Mobile Intel[®] Pentium[®] II Processor Specification Update

Release Date: October 2002

Order Number: 243887-045

The Mobile Pentium[®] II processor may contain design defects or errors known as errata which may cause the product to deviate from published specifications. Current characterized errata are documented in this Specification Update.

Figure 1. V_{CC}/V_{CCP} Timing Requirements (Mobile)

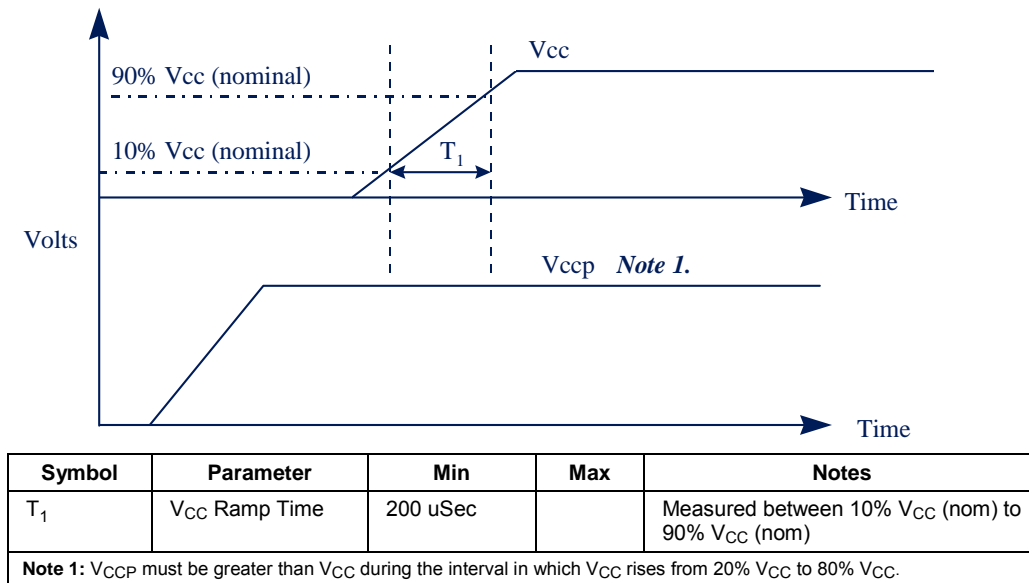
Problem: The processor uses the PWRGOOD signal to ensure that no voltage sequencing issues arise; no pin assertions should cause the processor to change its behavior until this signal is asserted, when all power supplies and clocks to the processor are valid and stable. However, if V_{CC} ramps up before V_{CCP} , it will cause the processor to enter an invalid state.

Implication: If this erratum occurs, the system may boot normally however, the L2 cache may not be initialized.

Workaround: For Mobile Pentium II processors, ensure that V_{CC} ramps after or with the L2 cache IO voltage (V_{CCP}). If V_{CCP} ramps after the V_{CC} , a delay circuit can be placed on the core V_{CC} to ensure that V_{CC} ramps at the same time or after V_{CCP} as shown below in Figure 1.

Figure 1. TAP Gageable Thread Clarification

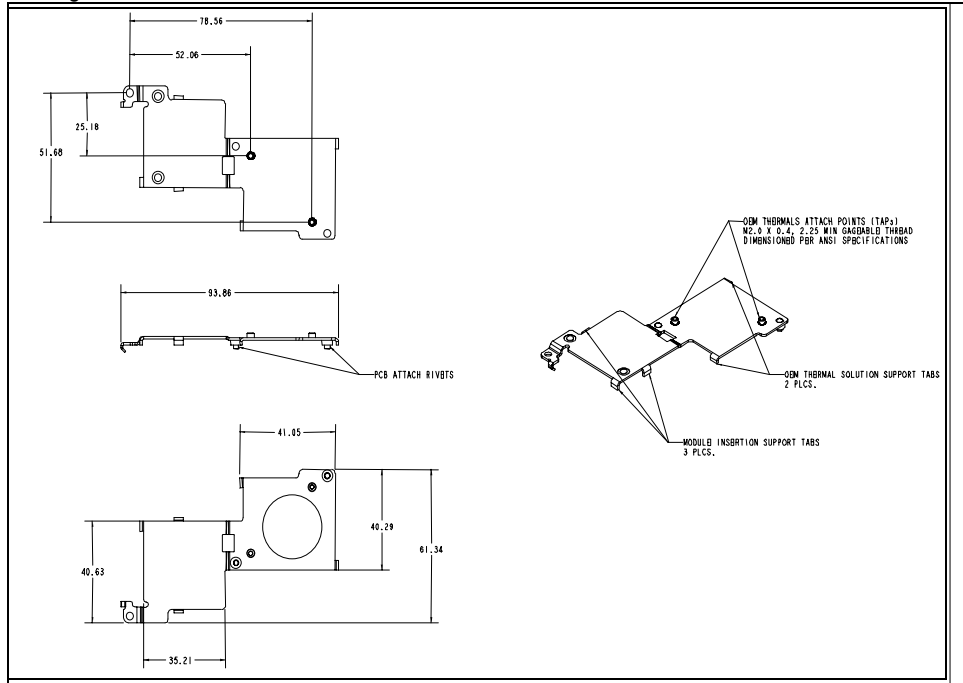
In the *Intel® Pentium® II Processor Mobile Module : Mobile Module Connector 1 (MMC-1)* and the *Intel® Pentium® II Processor Mobile Module : Mobile Module Connector 2 (MMC-2)* datasheets (Order Numbers 243667 and 243668, respectively), the thermal attach point (TAP) gageable thread specification was not clearly identified in Figure 14, of Section 5.2. The following is the TAP clarification:

OEM Thermal Attach Points (TAPs) M2.0 x 0.4, 2.25 min gageable thread dimensioned per ANSI specification.

See Figure 1 below for more information.
